FORD E4OD "UPDATE HANDBOOK"

*Updated
April, 2004*

VALVE BODY, SPACER PLATE, SPACER PLATE GASKETS, CHECKBALL LOCATIONS, AND CASE CHANGES, FOR THE 1996 MODEL YEAR

Figure 34

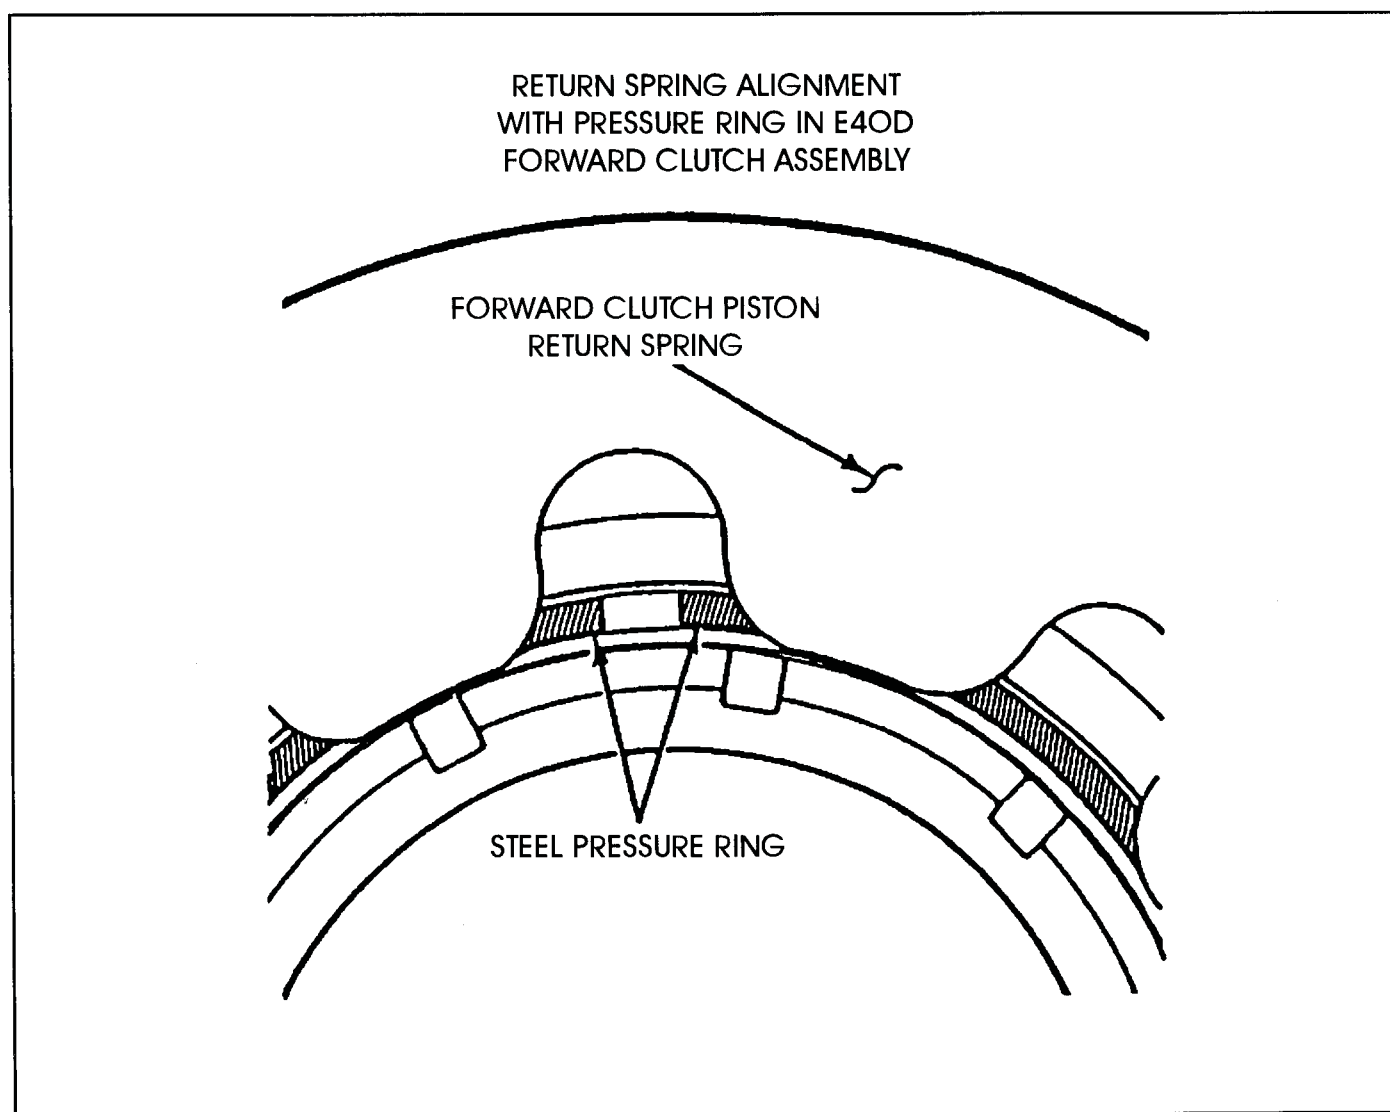
CAUSE: The cause may be, improper orientation of steel ring on top of the forward clutch piston, and the forward clutch piston return spring.

CORRECTION: Position the forward clutch piston return spring so that both ends of the steel ring are visible within the space between the two adjacent fingers of the return spring as shown in Figure 34.

Figure 35

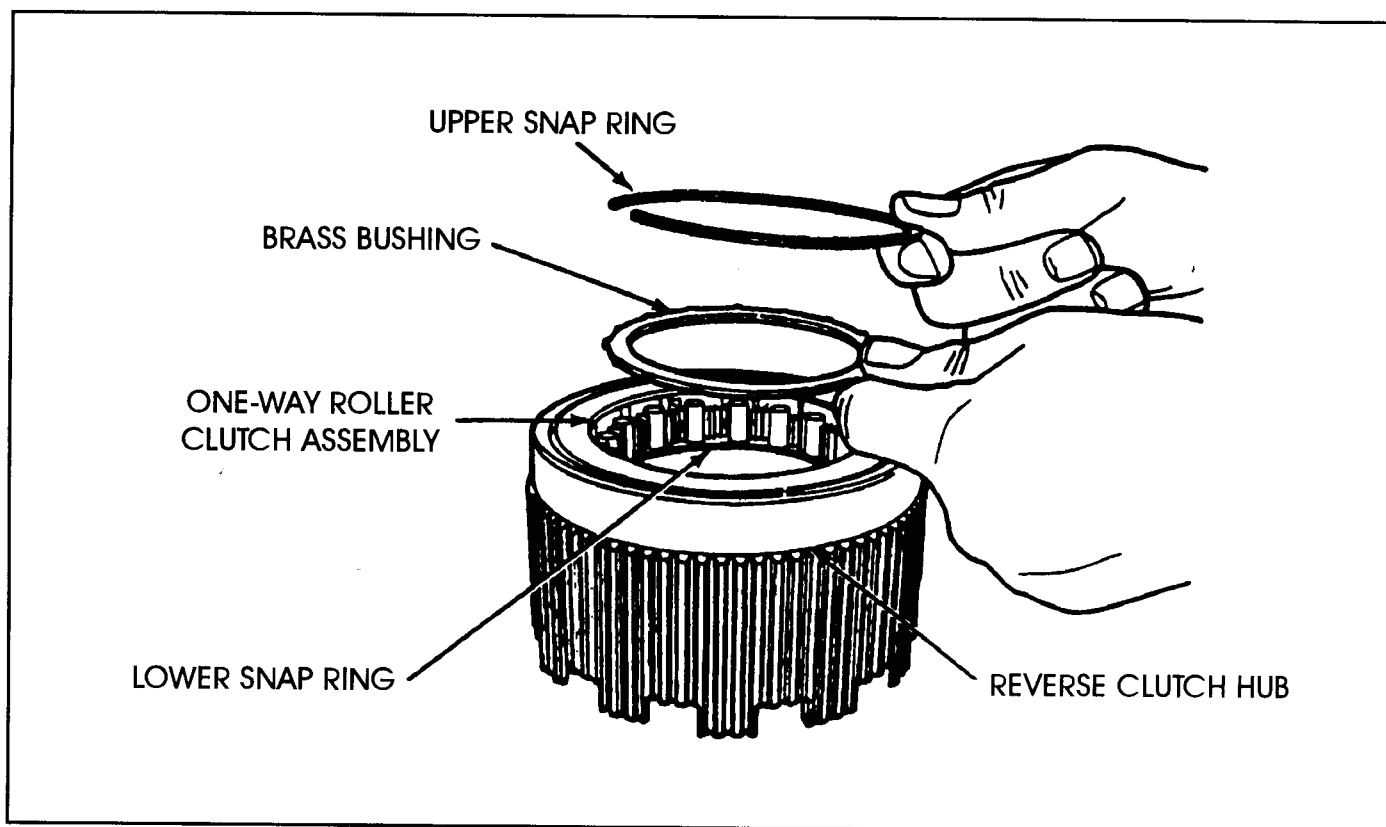
- (1) Remove the upper snap ring, brass bushing, roller clutch assembly, and the lower snap ring, as shown in Figure 35. **Discard all parts removed!**
- (2) Install the New Plastic Cage Low Roller Clutch Assembly through the **rear** side of the Reverse Clutch Hub, with the tabs on the rear edge. Seat the Low Roller Clutch into the Reverse Clutch Hub, and rotate clockwise to seat rollers and lock tabs in place. Refer to Figure 36 for proper installation.

Figure 37

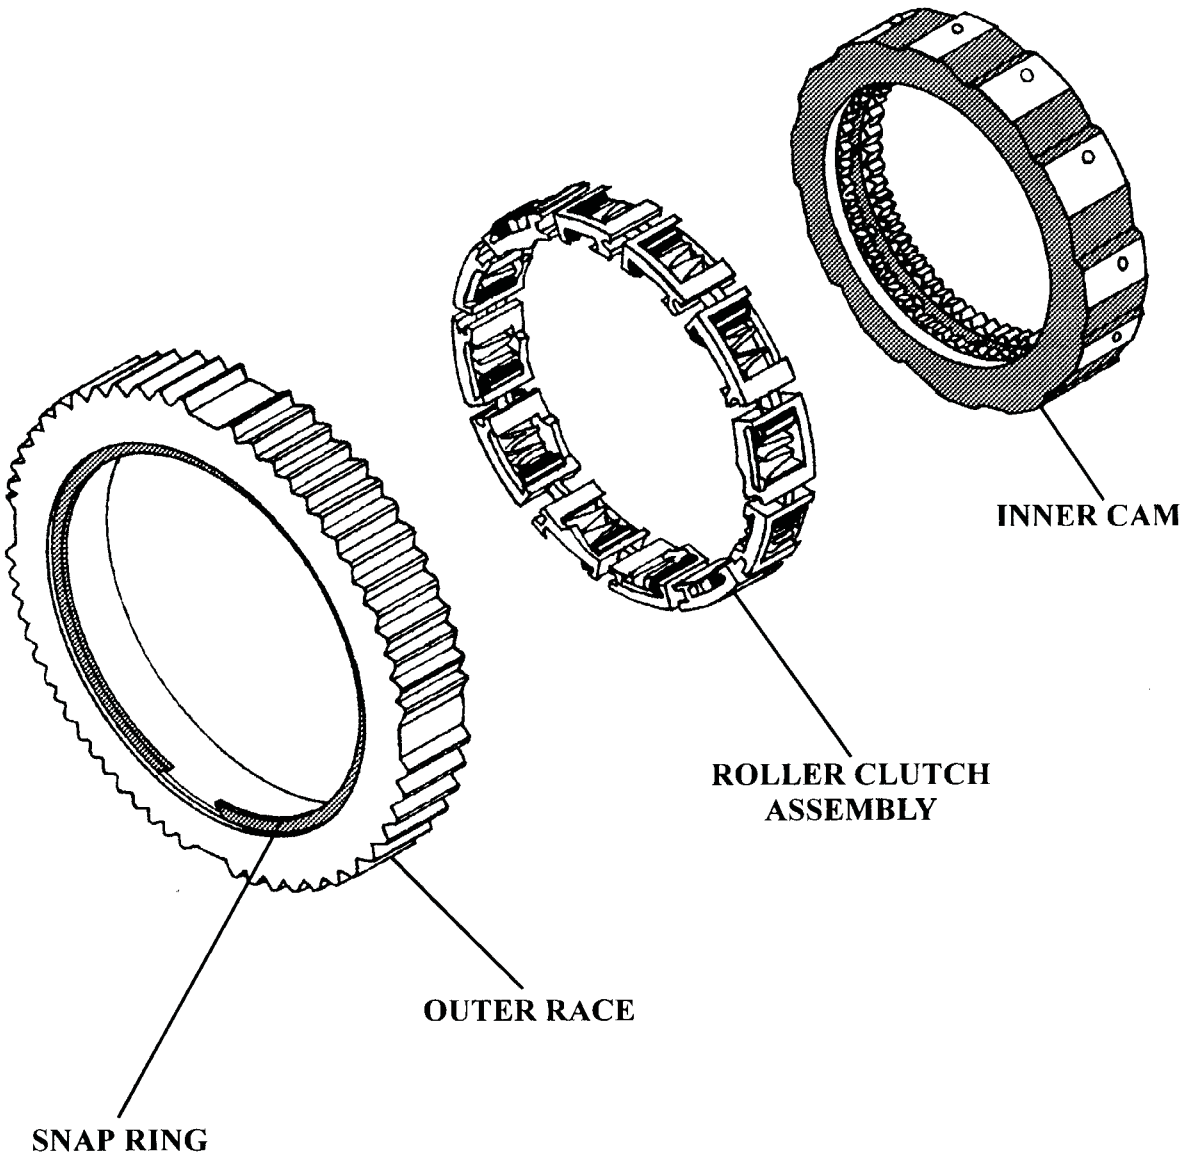
The previous design Overdrive Sprag (E9TZ-7A089-A) **is no longer available**. The previous part number will now supercede to one of the part numbers listed below under "Service Information", as there is one number for F-Super Duty and Motorhomes and another number for all others. The new design "Overdrive Roller Clutch Service Kit" will retro-fit back on **all** previous models (See Figure 37).

Figure 38

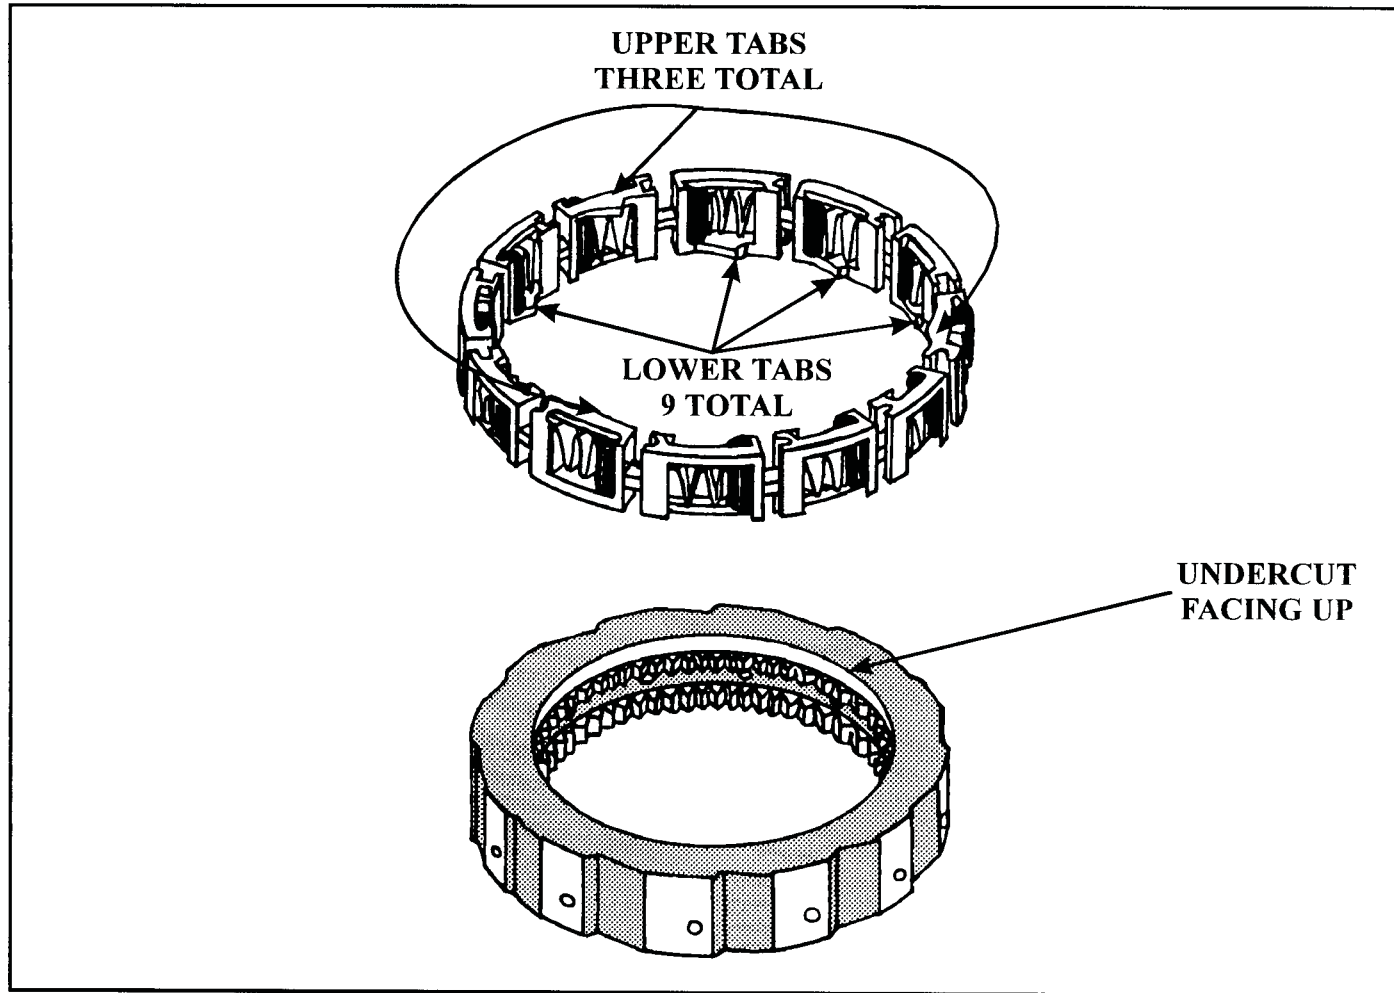
- (1) Place the new inner cam on a flat work surface with the "Undercut" on the inside diameter facing **up**, as shown in Figure 38.
- (2) Install the overdrive roller clutch assembly over the inner cam, **with the 9 locking tabs on the inner diameter facing down, and the three upper locking tabs facing up**, as shown in Figure 38.
- (3) Push the overdrive roller clutch assembly all the way down, as shown in Figure 39.
- (4) Install the snap ring into the groove in the outer race, as shown in Figure 40.
- (5) Install the outer race assembly over the overdrive roller clutch, by holding the inner cam and rotating the outer race in a clockwise direction, until fully seated, as shown in Figure 41.

Figure 42

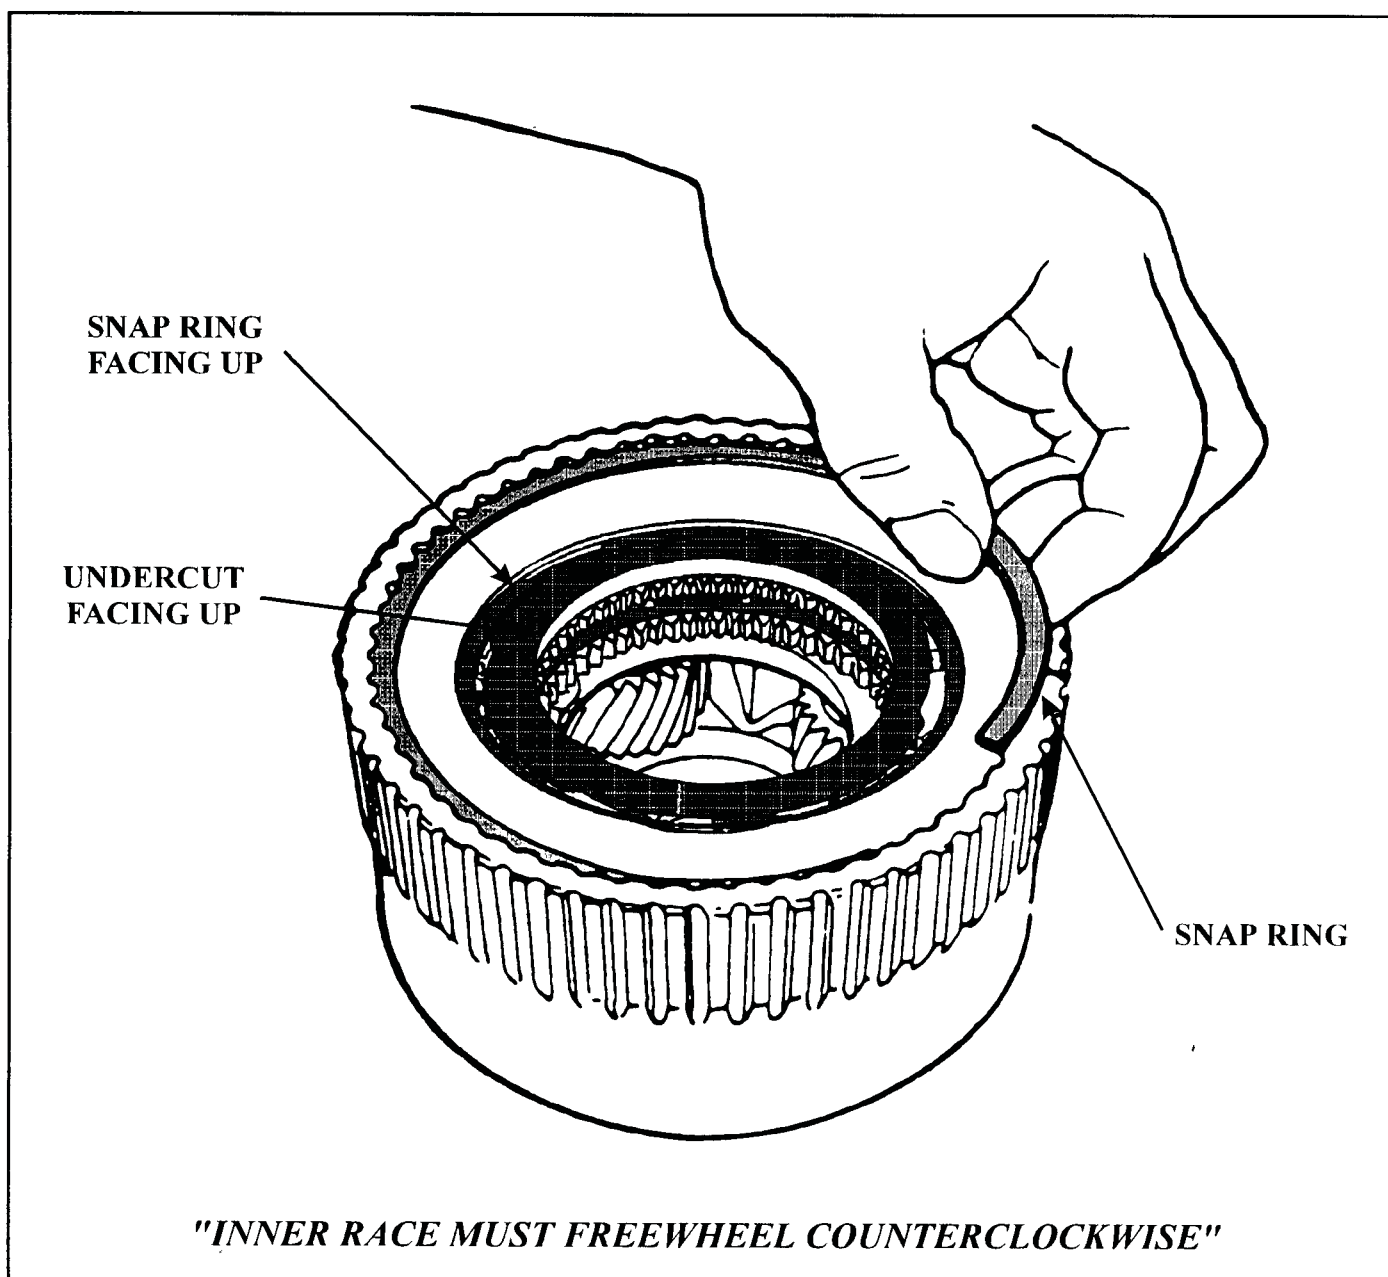
- (6) Install the completed Overdrive Roller Clutch Assembly into the overdrive ring gear, with the snap ring and the inner cam undercut, **facing up**, and install the outer race to ring gear snap ring, as shown in Figure 42.

Figure 43

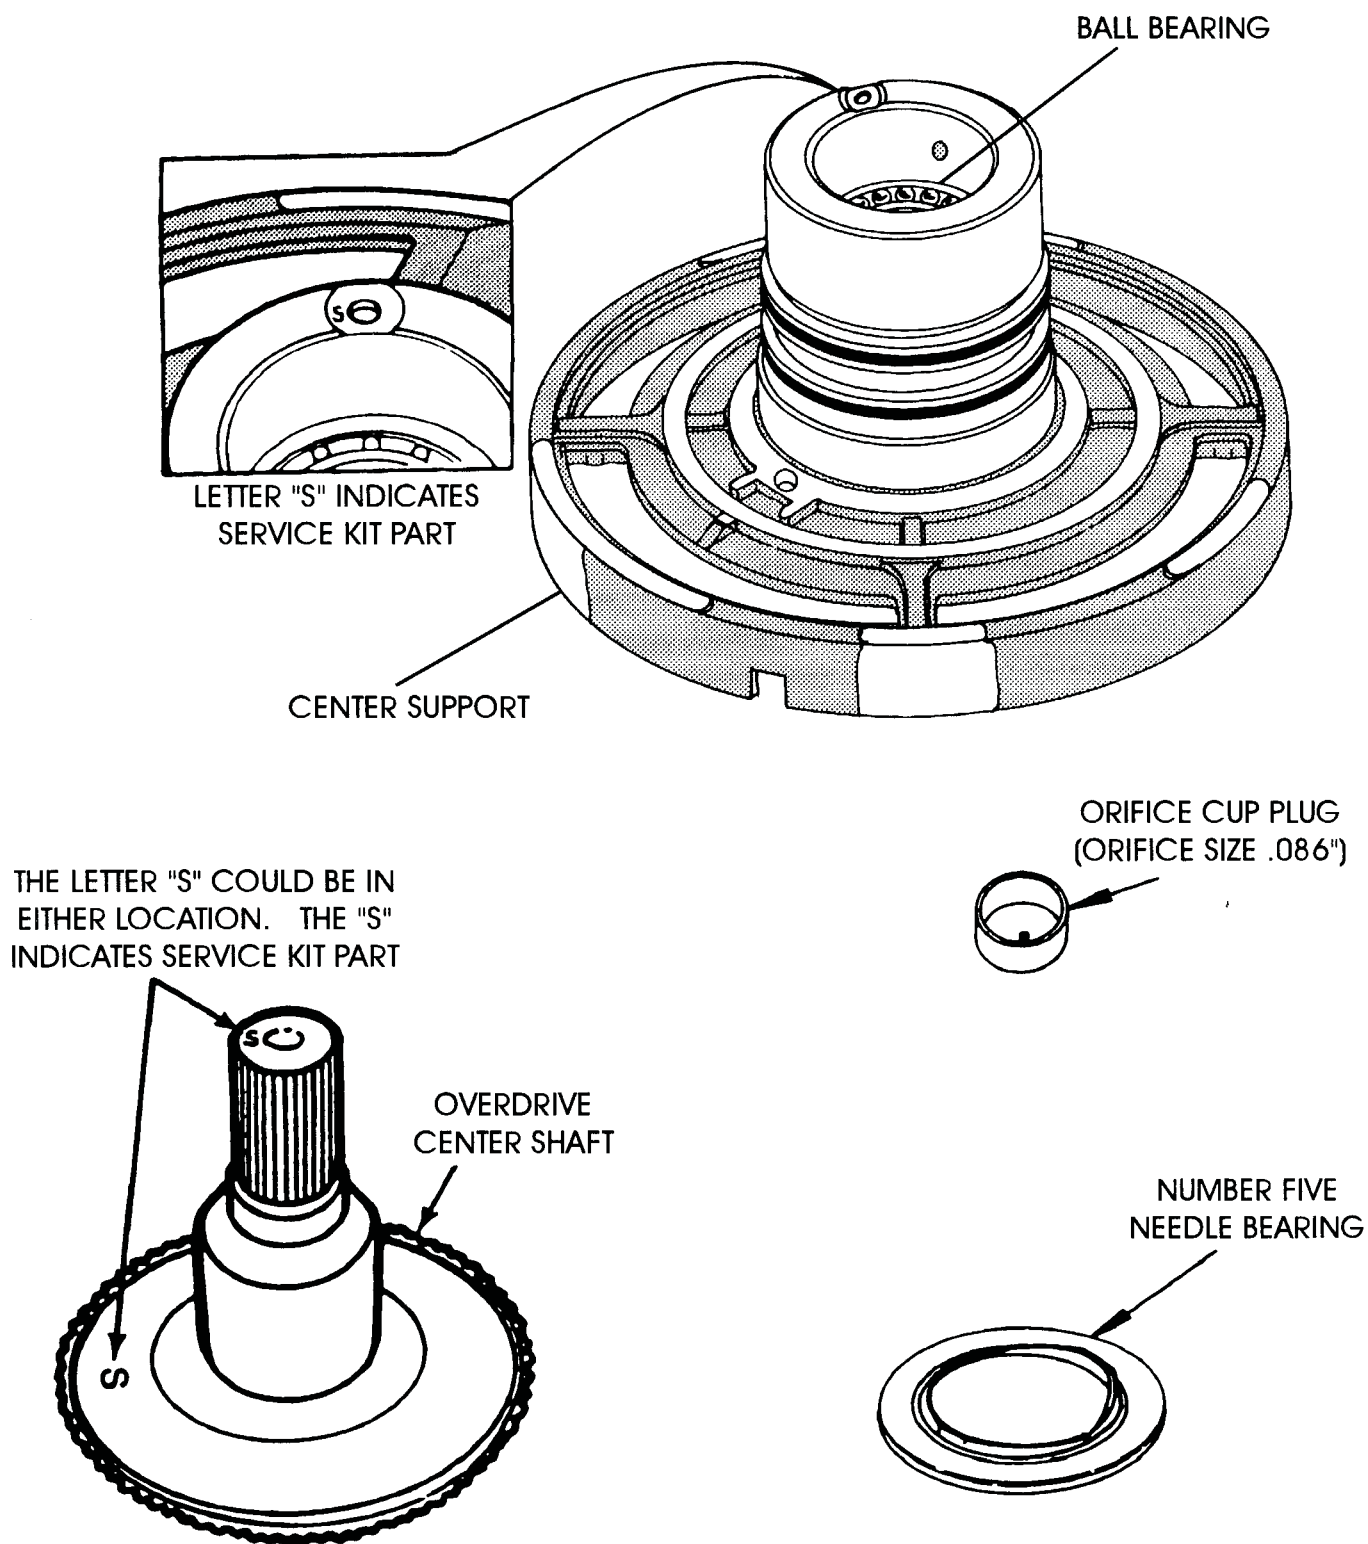
CHANGE: There is now available, from Ford Motor Co, a new design Center Support Service Kit with a ball bearing in the support. The new design service package is available under OEM part number F4TZ-7A130-B, and will back service all past model 89-94 E4OD transmissions only. The parts in this service kit are different dimensions than 1995 model year production parts. Refer to Figure 43 for service package kit contents.
